# REGULATORY INFORMATION DISTRIBUTION SYSTEM (RIDS)

SUBJECT: Forwards marked-up FSAR pages to show necessary changes, in addition to 860819 submittal. Summary of changes & explanation of each change to aid review of matl included. W/affidavit & 26 oversize encls.

August 22, 1986  
NMP2L 0851

As a result of Niagara Mohawk's verification of the Final Safety Analysis Report for Nine Mile Point Unit 2, we are submitting Final Safety Analysis Report pages marked to show the necessary changes. These changes are in addition to those in our August 19, 1986 submittal.

FIGURE 6.2-42

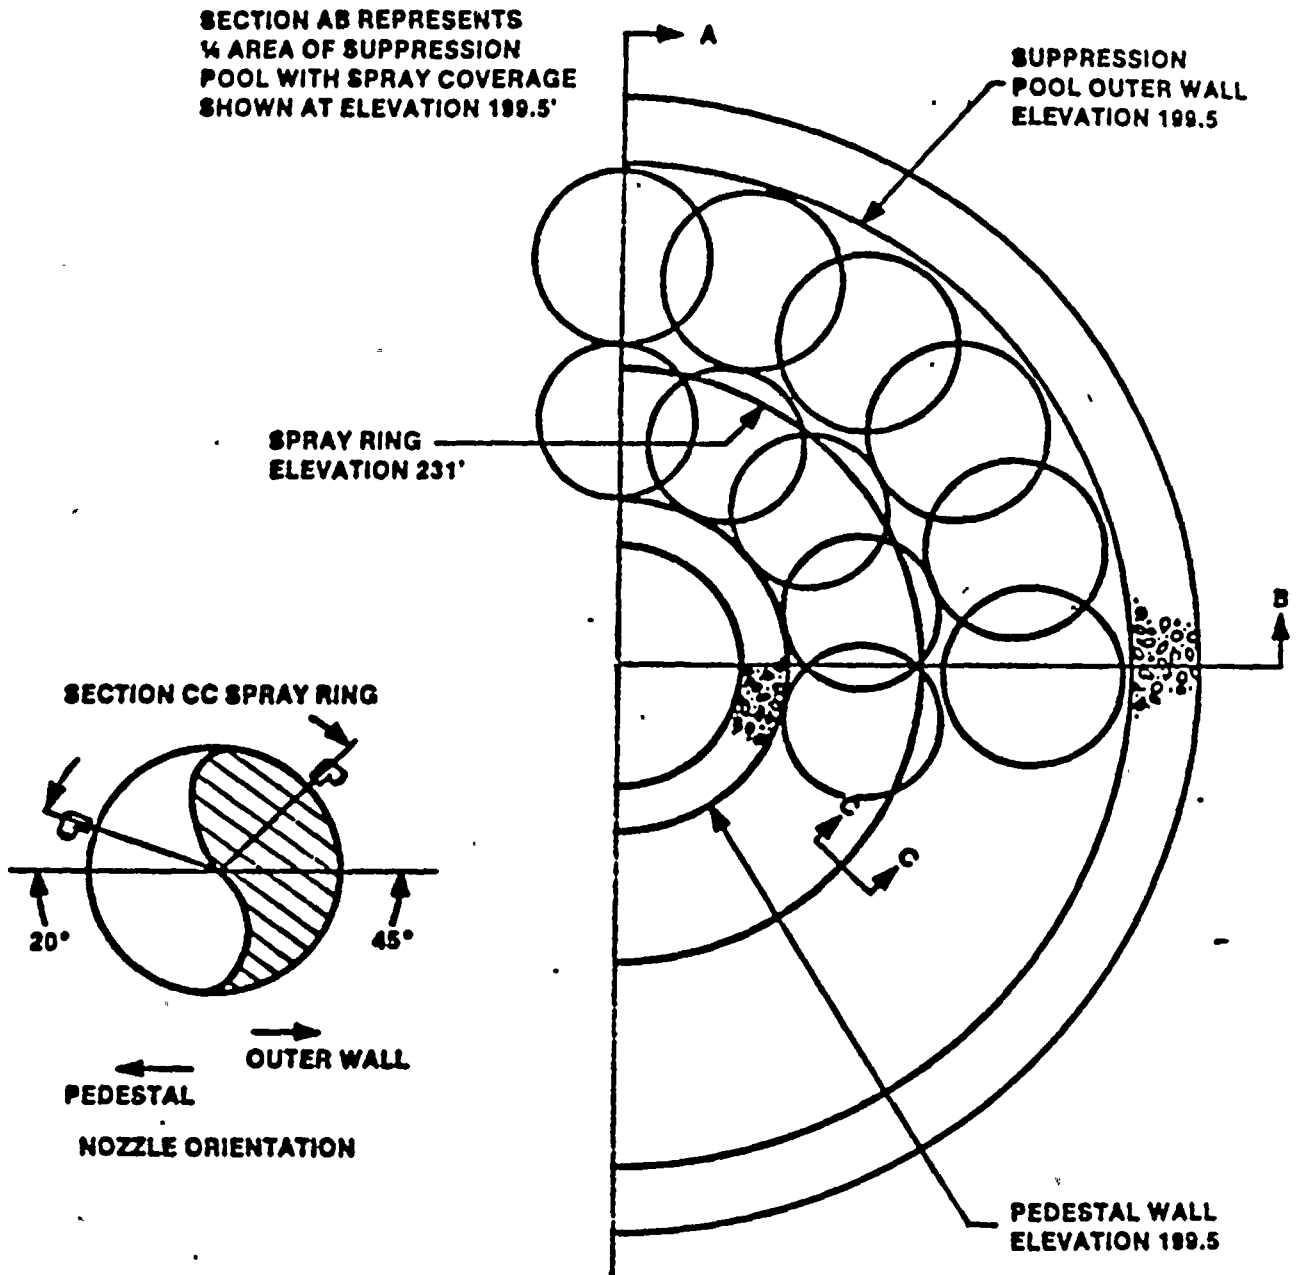
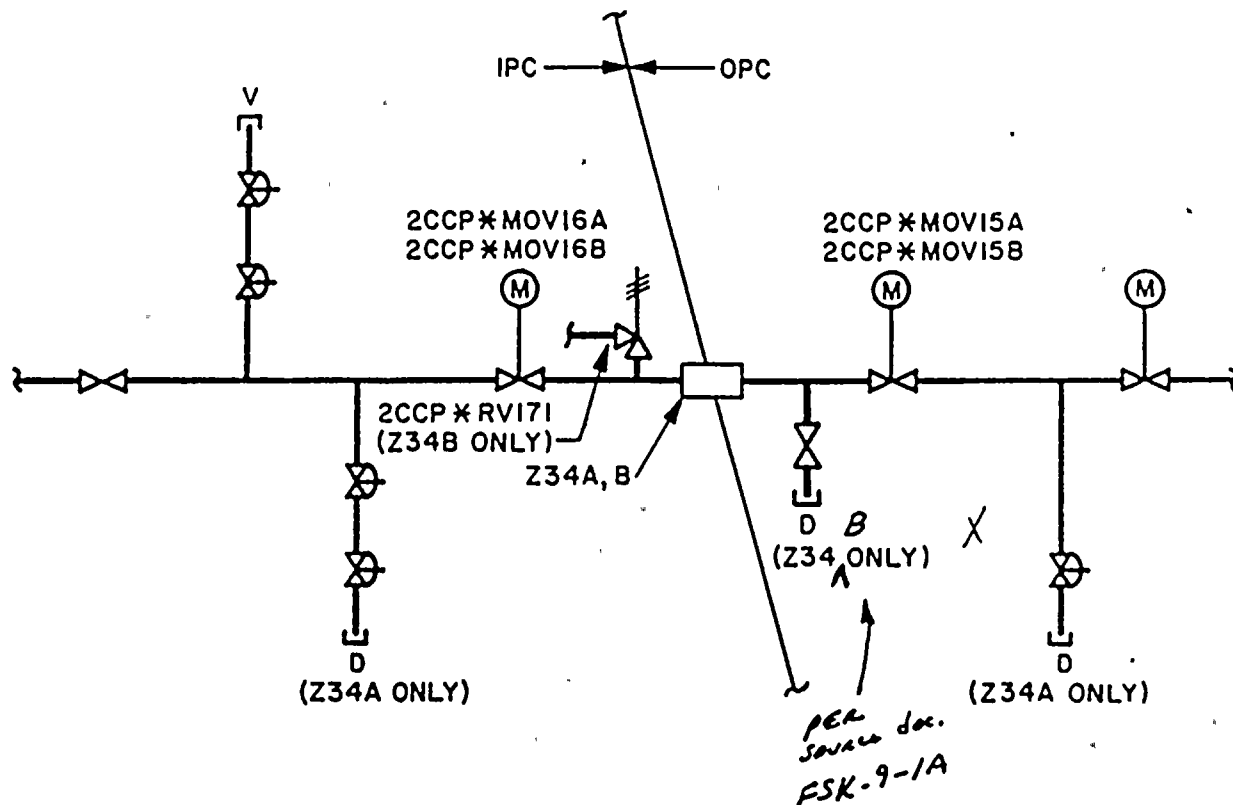
THIS FIGURE HAS  
BEEN DELETED

REPLACE WITH  
INSERT "A"  
(FOLLOWING  
PAGE)

FIGURE 6A.4-40

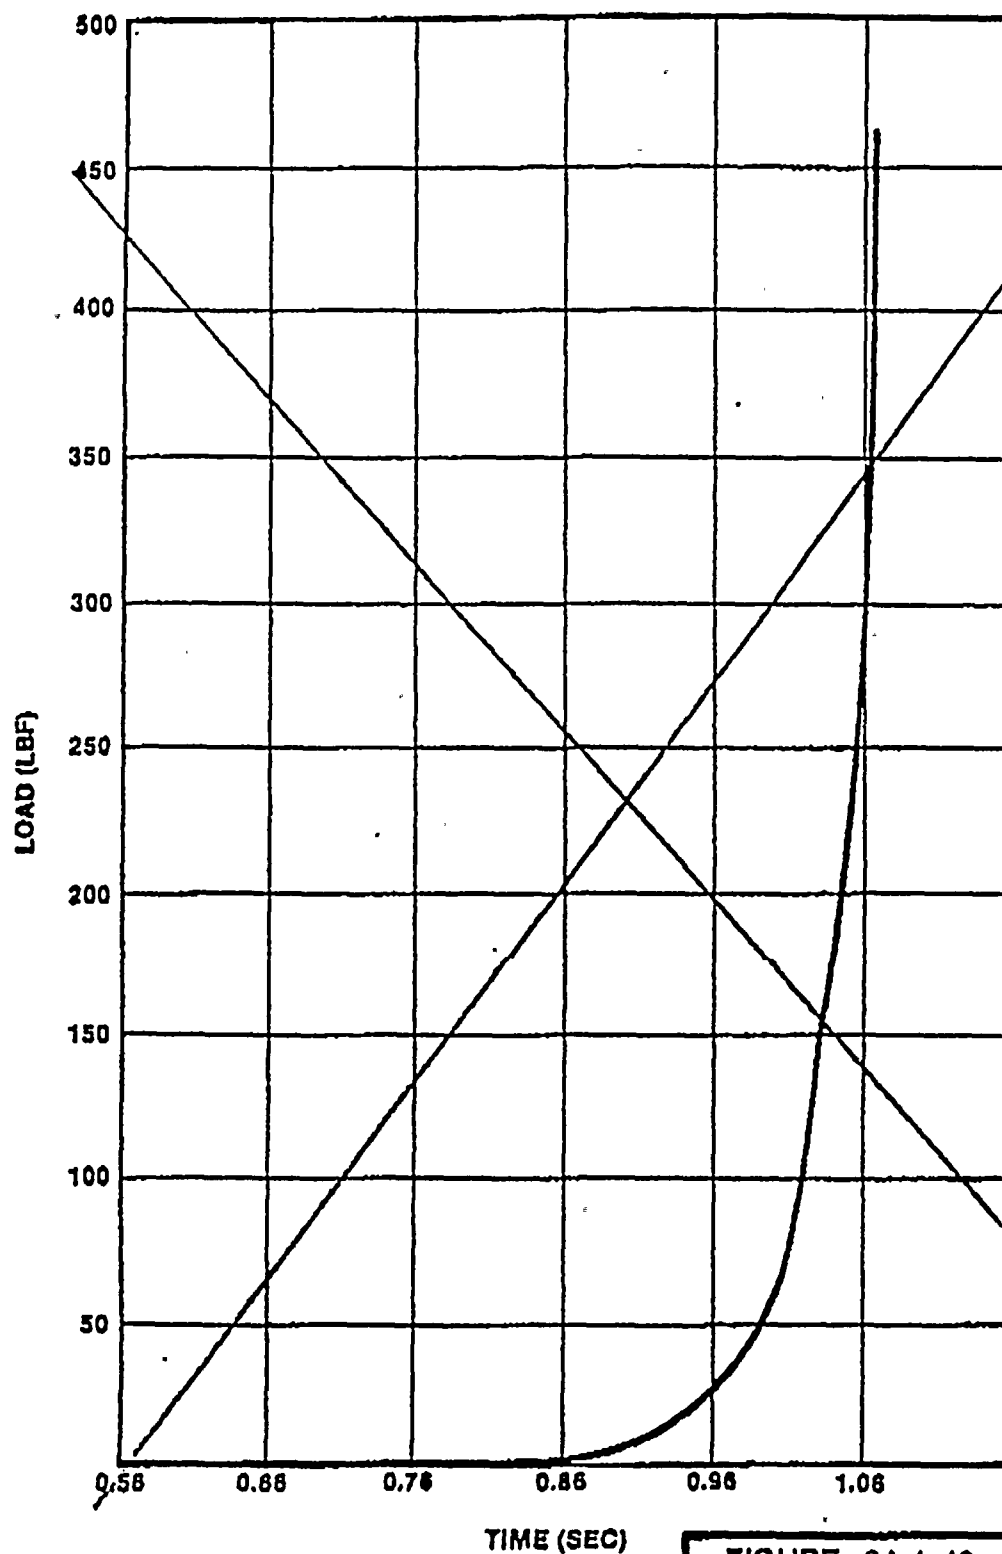
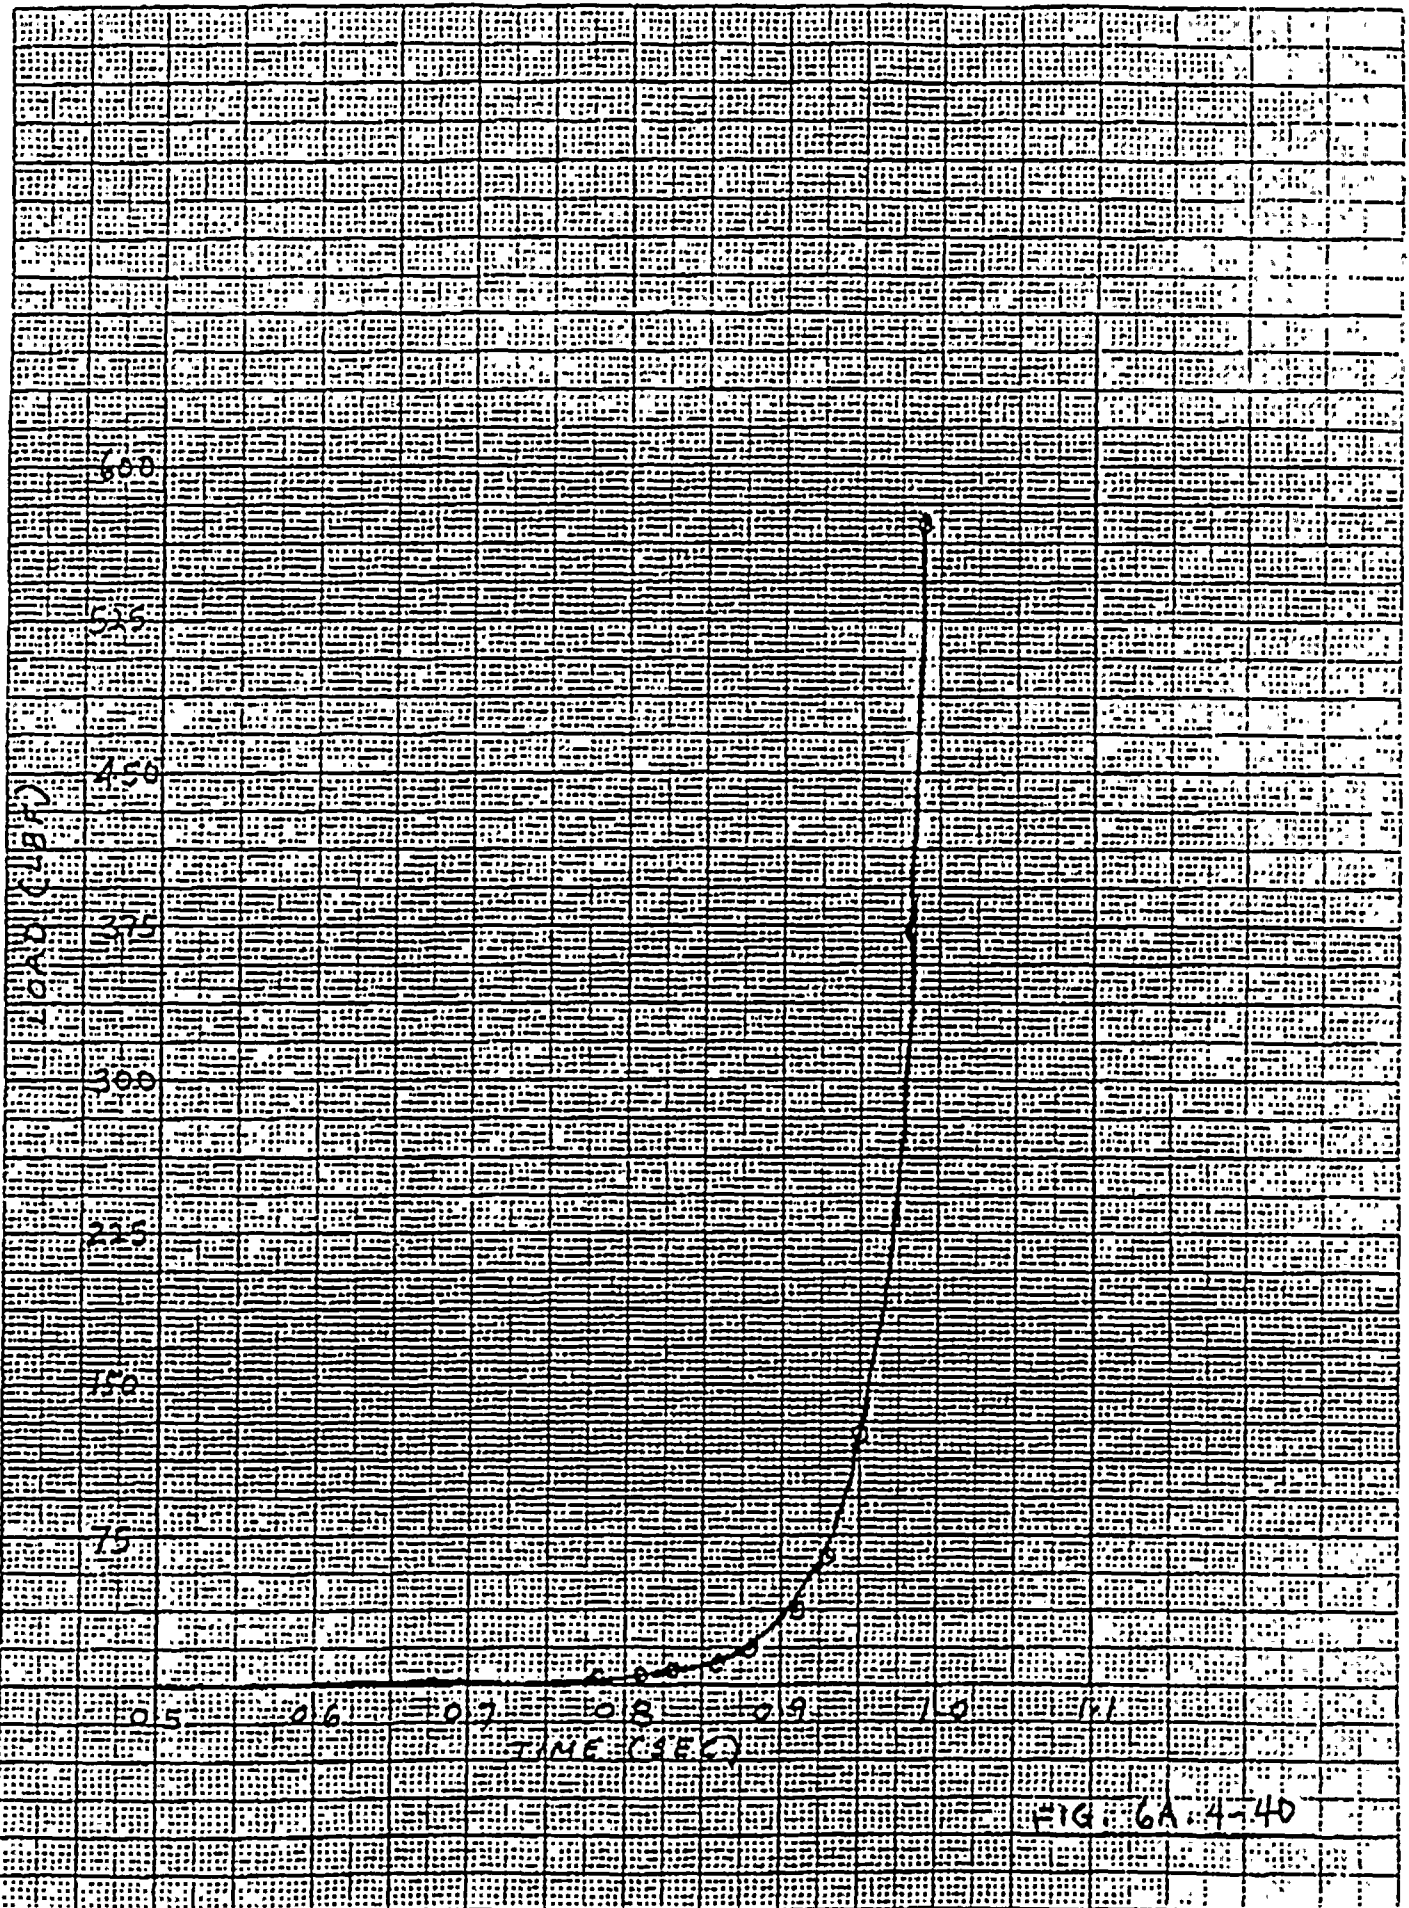
Page 6.5-9	Delete the sentence that mentioned the drywell and suppression chamber sprays rated flows.	The rated flows for drywell and suppression chamber as mentioned in FSAR page 6.2-46a.	E	No	No
Figures 6A.4-40 and 6A.4-41	Replace the figures with attached new figures.	The new figures reflect actual design.	E	No	No
Page 7.1-7	Change FSAR to committ to set-point methodology in FSAR.	Our letter #0604 dated 2/7/86 committed to include this in the FSAR.	R	No	No
